Model: Martini-C1 Finisher (SR860/SR850)  Date				e: 13-Nov-0	2	No.: MB468001
Modified Article: S	lide Rail Bracket Screw	Prepared	by: M.	Гsuyuki		
From: Technical Services sec. Service Planning Dept.						
Reason for	Parts catalog correction	☐ Vend	dor ch	ange	☐ To n	neet standards
Modification:	☐ To facilitate assembly	sembly 🛛 To improv		e reliability	(	)
	☐ Part standardization	☐ Othe	r

Model: Martini-C1 Finisher (SR860/SR850)

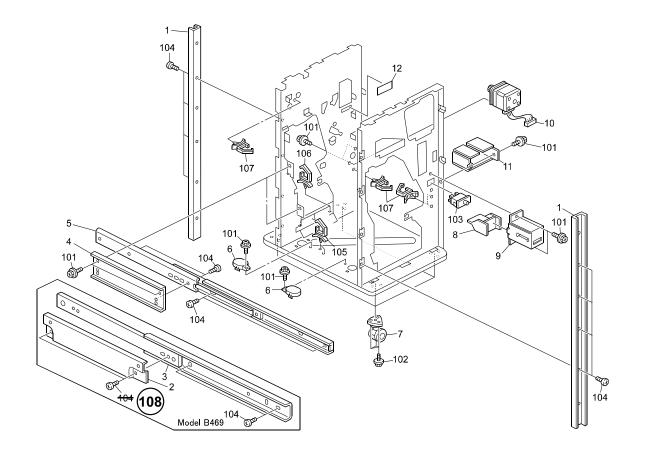
The screws that fixed slide rail bracket may loosen because of vibration during transportation. To prevent this, the following part has been changed:

Old part	New part	Description	Q'ty	Int	Page	Index	Note
number	number						
04533006B —		Tapping Screw - M3x6			45	104	
1	→09503006B	Sem,s Screw - M3x6		X/O	45	108

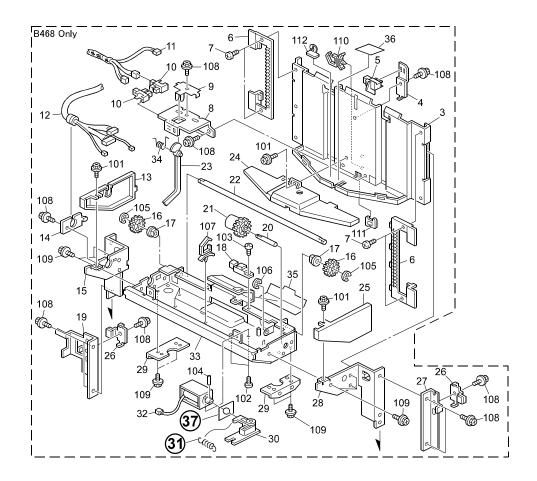
The tension of the spring for the End Fence Spring Clutch has been reduced to ensure the clutch is not damaged when the solenoid turns off. In addition, a cushion has been added to ensure noise does not occur between the solenoid and release lever from the reduced spring tension.

Old part	New part	Description	Q'ty	Int	Page	Index	Note
number	number						
B4683146	B4683145	Tension Spring	1	X/O	33	31	
	B4683143	Cushion - Solenoid Spring Clutch	1		33	37

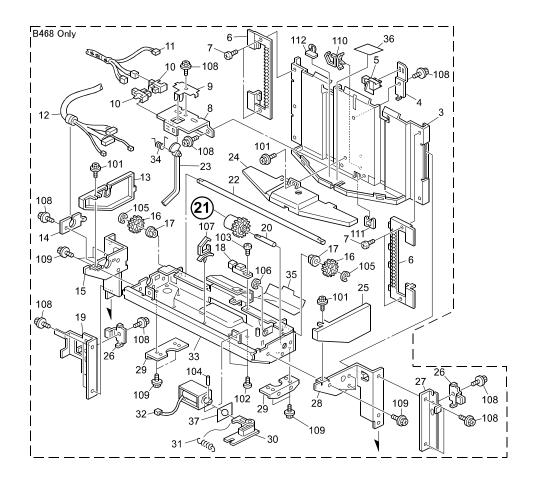
The material of the spring in the Spring Clutch has been changed to metal to increase clutch durability.

Old part number	New part number	Description	Q'ty	Int	Page	Index	Note
B4683149	B4683196	Spring Clutch - End Fence	1	X/O	33	21

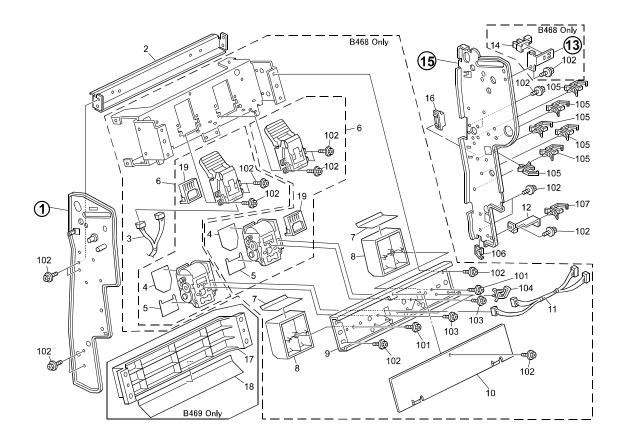
The following have been changed to ensure that when selecting two-position stapling, the staple stay is not deformed by the weight of the staple unit, which can cause the rear staple to shift to the left.

Old part	New part	Description	Q'ty	Int	Page	Index	Note
number	number						
B4684211	B4684215	Front Side Plate (B468)	1	X/X	25	1	Α
B4684212	B4684216	Front Side Plate (B469)	1	X/X	25	1	В
B4684221	B4684225	Rear Side Plate (B468)	1	X/X	25	15	Α
B4684222	B4684226	Rear Side Plate (B469)	1	X/X	25	15	В
B4684555	B4684556	Stapler Guide Rod	1	X/X	27	13	A, B

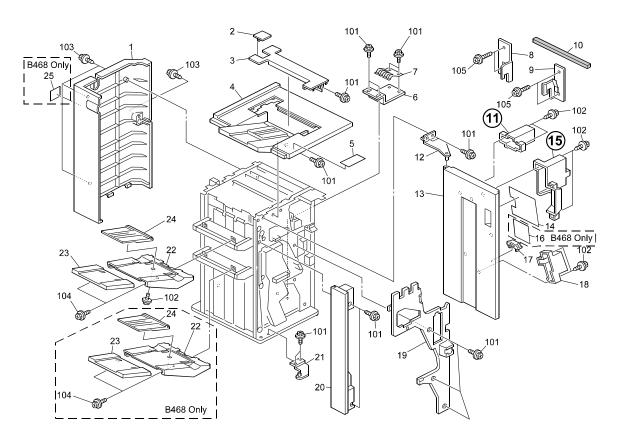
When closing the front door without repositioning the R2 or R3 lever, the shaft of the lever may be damaged. To prevent this, the following parts have been changed:

Old part	New part	Description	Q'ty	Int	Page	Index	Note
number	number						
B4681622	B4681627	Front Grip	1	X/X	7	15	
B4681623	B4681628	Upper Stopper	1	X/X	7	11	
B4682152	B4682153	Upper Guide Plate	1	X/X	9	8

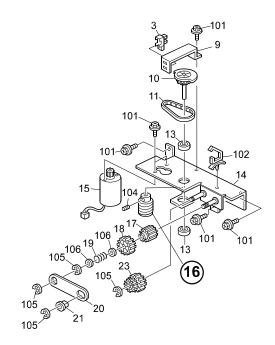
To prevent damage to the timing belt, the following parts have been changed:

Old part	New part	Description	Q'ty	Int	Page	Index	Note
number	number						
B4683231	B4683233	Front Stopper	1	X/O	35	21	
B4683232	B4683234	Rear Stopper	1	X/O	35	24

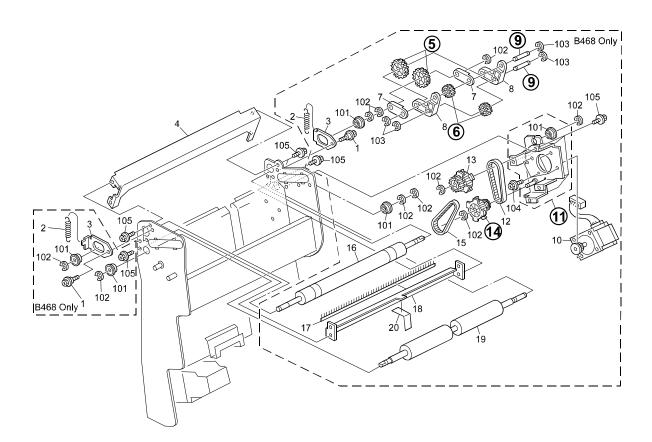
To increase durability, the materials of the following parts have been changed:

Old part	New part	Description	Q'ty	Int	Page	Index	Note
number	number						
B4684651	B4684628	Drive Gear	2	X/O	31	5	
B4684624	B4684627	Gear - 18Z	2	X/O	31	6	
B4684623	B4684629	Roller Shaft	2	X/O	31	9	
B4684635	B4684634	Bracket	1	X/O	31	11	
B4684652 ¬		Idler Pulley - T20P5MZ20	1	X/O	31	13	
Ī	<b>→</b> B4684649	Idler Pulley - T20P5M	1	X/O	31	13

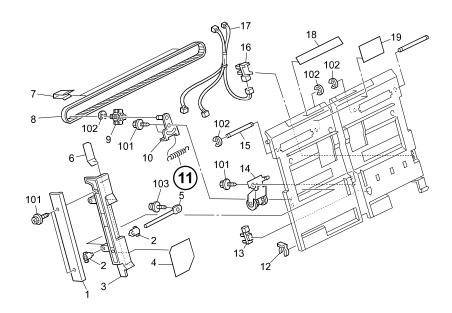
The following has been changed to ensure that proper tension is maintained in the jogger drive belt under low temperature conditions.

Old part	New part	Description	Q'ty	Int	Page	Index	Note
number	number						
A6971518 —		Spring - Oil Blade	1		21	11	
	→ B4684333	Tension Spring - 10.6N	1	X/O	21	11

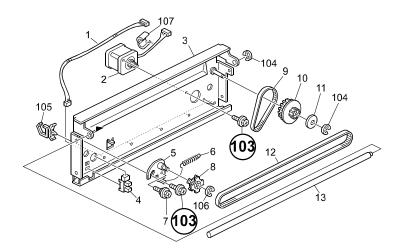
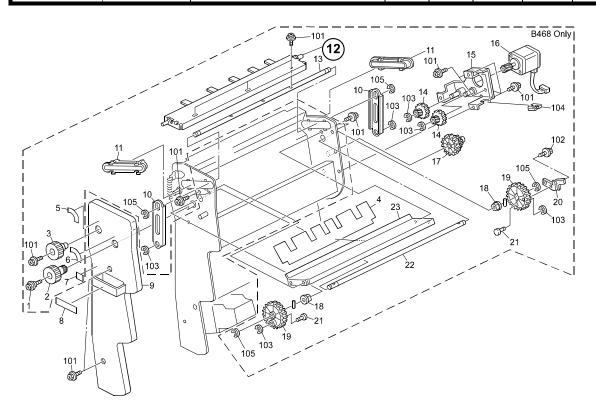
The following part has been changed to facilitate assembly.

Old part	New part	Description	Q'ty	Int	Page	Index	Note
number	number						
04513006B -	1	Tapping Screw - M3x6			23	103	
					27	103	
	→09503005B	Phillips Screw With Spring		X/O	23	108	
		Washer			27	108

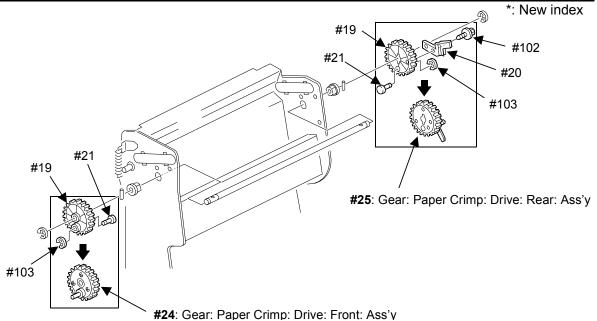
To ensure the Drive Gear is not damaged, support plates have been added to both sides. To facilitate serviceability, the parts below are supplied as assemblies.

Old part	New part	Description	Q'ty	Int	Page	Index
number	number					
B4684742 ¬		Drive Gear	1 - 0			19
B4684743 <b>-</b>		Link Shaft	1 - 0	X/	29	21
07200040B <b>-</b>		Retaining Ring – M4	n - n-1		29	103
l.	B4684741	Gear: Paper Crimp: Drive: Front: Ass'y	0 - 1	/O		*24
B4684742 <b>¬</b>		Drive Gear	1 - 0			19
B4684732 <b>–</b>		Shielding Plate Bracket	1 - 0			20
B4684743 -		Link Shaft	1 - 0	X/	29	21
04503008B -		Tapping Screw - M3x8	n - n-1		29	102
07200040B		Retaining Ring – M4	n - n-1			103
	B4684731	Gear: Paper Crimp: Drive: Rear: Ass'y	0 - 1	/0		*25

Modified Article: Ferrite Core				Prepared by: K. Miura		
From: 1st Tech. Support Sec. Service Support Dept.						
Reason for	☐ Parts catalog correction	☐ Vendor ch	ange	☐ To meet standards		
Modification:	☐ To facilitate assembly	⊠ To improve	e reliability	( )		
	☐ Part standardization	☐ Other

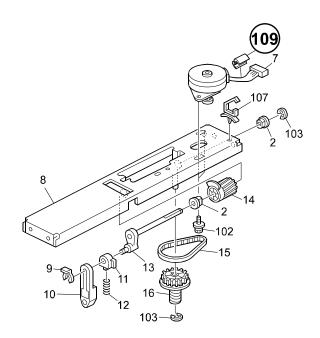
The following has been added to prevent static-electrical noise.

Old part	New part	Description		Int	Page	Index	Note
number	number						
	16070623	Ferrite Core - TFC-16-8-13	1		13	109

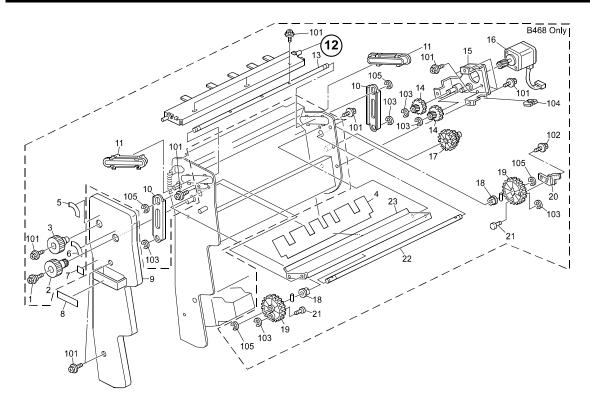
The paper-folding bracket has been changed to further minimize damage to the paper.

Old part	New part	Description	Q'ty	Int	Page	Index	Note
number	number						
B4684711	B4684716	Bracket	1	X/O	29	12

Modified Article: Support plate			Prepared by: Y.Urushihara		
From: 1st Tech. Support Sec. Service Support Dept.					
Reason for	☐ Parts catalog correction	☐ Vendor ch	ange	☐ To meet standards	
Modification:	☐ To facilitate assembly			( )	
	☐ Part standardization	☐ Other

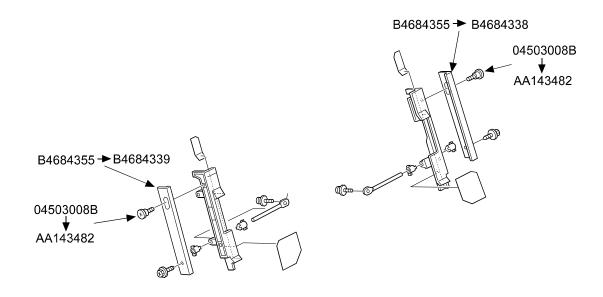
The following modifications have been made to ensure the jogger fences stay properly aligned even if the plastic expands by heat:

- The screw holes in the metal support plates for the fences have been lengthened to allow the jogger fence to expand.
- The shapes of the front and rear support plates have been changed.
- The upper screw for the plate and jogger fence has been changed to a stepped screw.

Old part	New part	Description	Q'ty	Int	Page	Index	Note
number	number						
B4684335		Protect Bracket	2-0		21	1	
-	►B4684339	Support plate – front jogger fence	0-1		21	1	Α
	►B4684338	Support plate – rear jogger fence	0-1		21	31	Α
04503008		Tapping Screw – M3x8			21	101	Α

Modified Article: Cover

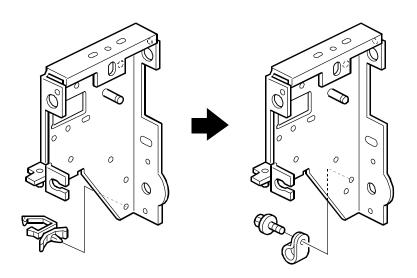
**Note:** When installing these parts, you must replace the parts marked "A" **together as a set**.

Old part	New part	Description	Q'ty	Int	Page	Index	Note
number	number						
B4681632	B4681625	Front Cover	1	0/0	7	13	Α
B4681627	B4681629	Front Grip	1	0/0	7	15	Α

Modified Article: Bracket			Prepared by: S. Watanabe		
From: 2nd Tech. Su	pport Sec. Service Support De	pt.			
Reason for	Parts catalog correction	☐ Vendor ch	ange	☐ To meet standards	
Modification:	☐ To facilitate assembly	oxtimes To improve reliability		( )	
	☐ Part standardization	☐ Other

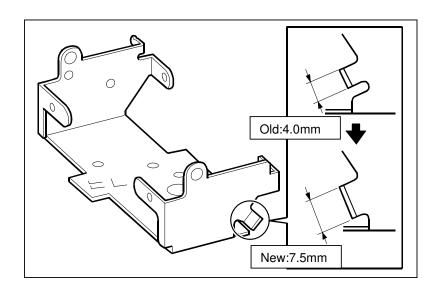
The bracket has been modified to prevent the home position error.

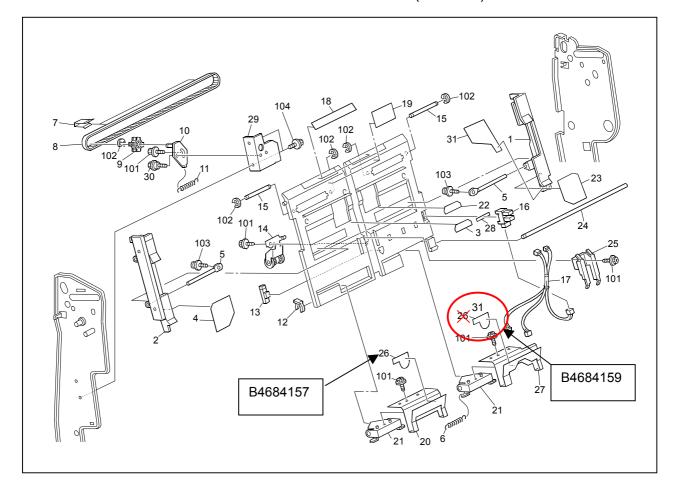
**Change:** The shape of the part was changed.

Old part	New part	Description	Q'ty	Int	Page	Index	Note
number	number						
B4684157		Guide Myler	2 -> 1	-	21	26	
_	— B4684159	Guide Myler: Rear	0 -> 1	O/O	21	31

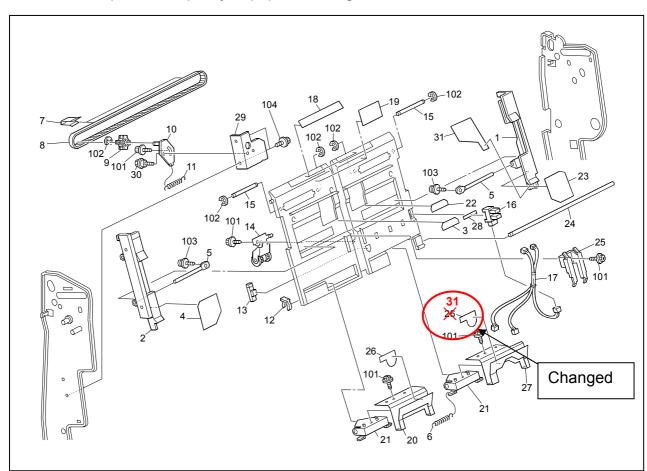
**Change:** The shape of this part was changed. **Reason:** To improve the quality of paper stacking.

Old part	New part	Description	Old	New	Int	Page	Index	Note
number	number	-	Q'ty	Q'ty				
B4684157	-	Guide: Myler	2	1	-	20	26	
B4684157	B4684159	Film: Guide: Standard Fence: Staple	1	1	0/0	20	31
